Response to Planning application from Hertfordshire County Council (T and CP GDP Order 2015)

District ref: 24/01434/S73
HCC ref: NH/21517/2024
HCC received: 26 November 2024
Area manager: Manjinder Sehmi
Case officer: Senober Khan

Friends Green Farm, Friends Green, Damask Green Road, Weston, Hitchin, SG4 7BU

Section 73 Application : Removal of condition 2 of planning permission
23/01259/FP granted 25.03.2024 for Use of buildings as (Sui Generis) car sales and
(Use Class B2 general industrial) car servicing (as amended by details submitted
16th January 2024).

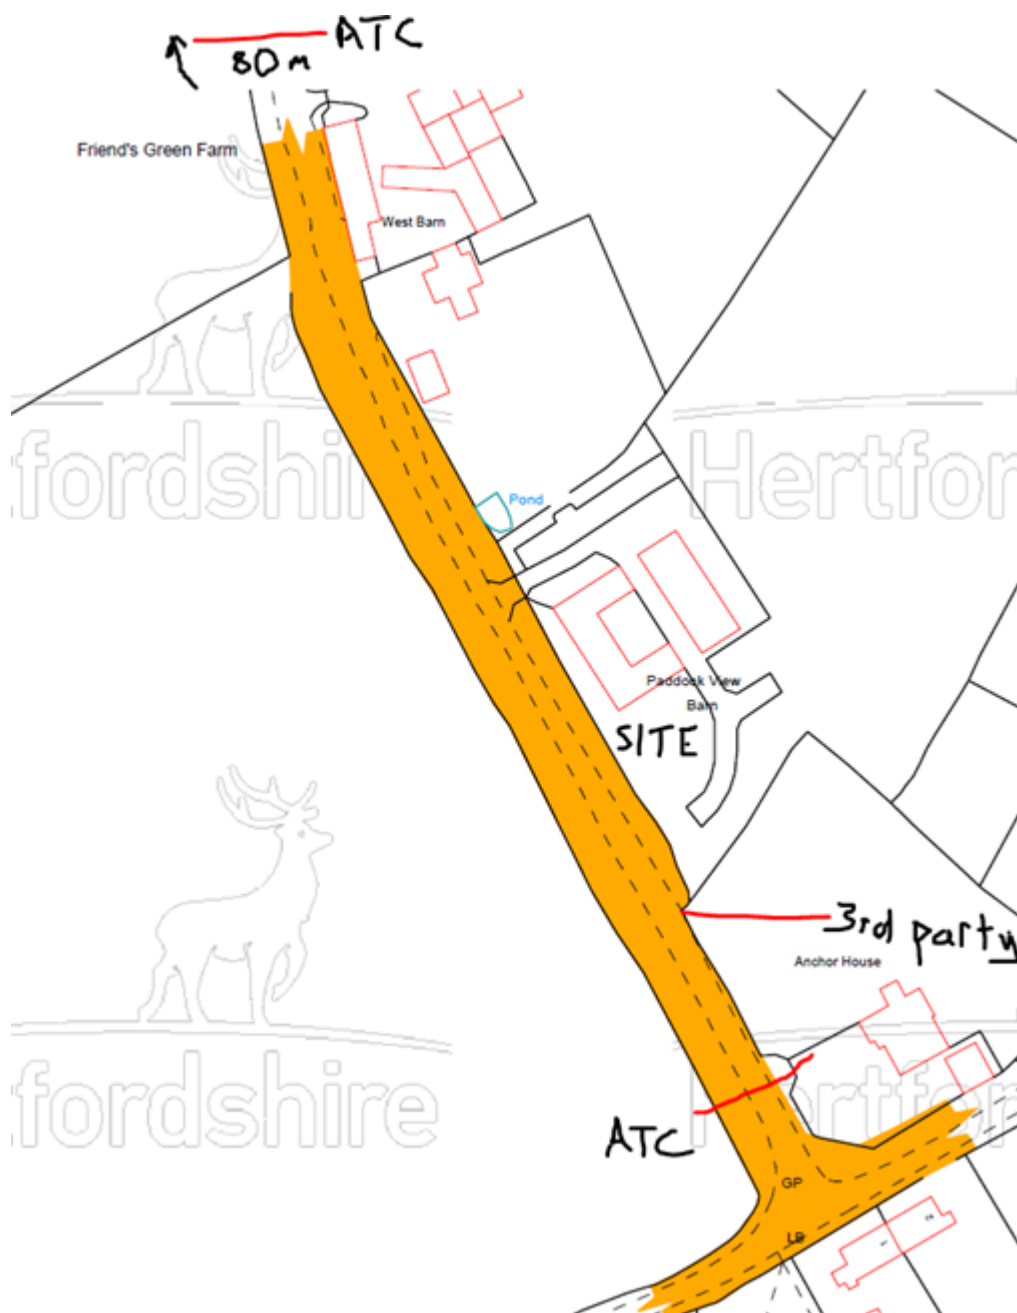
It should be noted the speed survey ATC's were placed approx 180m north from the northern vehicle access and approx 50m south of the southern vehicle access approx 20m from Damask Green Road/Warrens Green Lane junction. Consequently the recorded speeds are questionable given that vehicles travelling southbound at the northern ATC will be coming from a bend in the road, and at the southern ATC vehicles heading northbound will be turning from Warrens Green Lane into Damask Green Road would be in the early stages of accelerating and only 20m from the junction conversely traffic heading south would be decelerating in approaching the ATC and junction, in both cases the recorded speeds are not representative of traffic speed at the sites frontage. No information or justification has been provided why the ATC's were placed so far away from the site at such locations.

The Highway Boundary Mapping the applicant obtained from HCC shows third party land extends to the back of the carriageway (no verge no highway land), so all vegetation/foliage is on third party land.

To verify the above comments the ATC's have been approx marked on the plan below from information obtained from the applicants Transport Technical Note June 2024, which also shows the highway boundary and third party land/sites boundary/public highway.
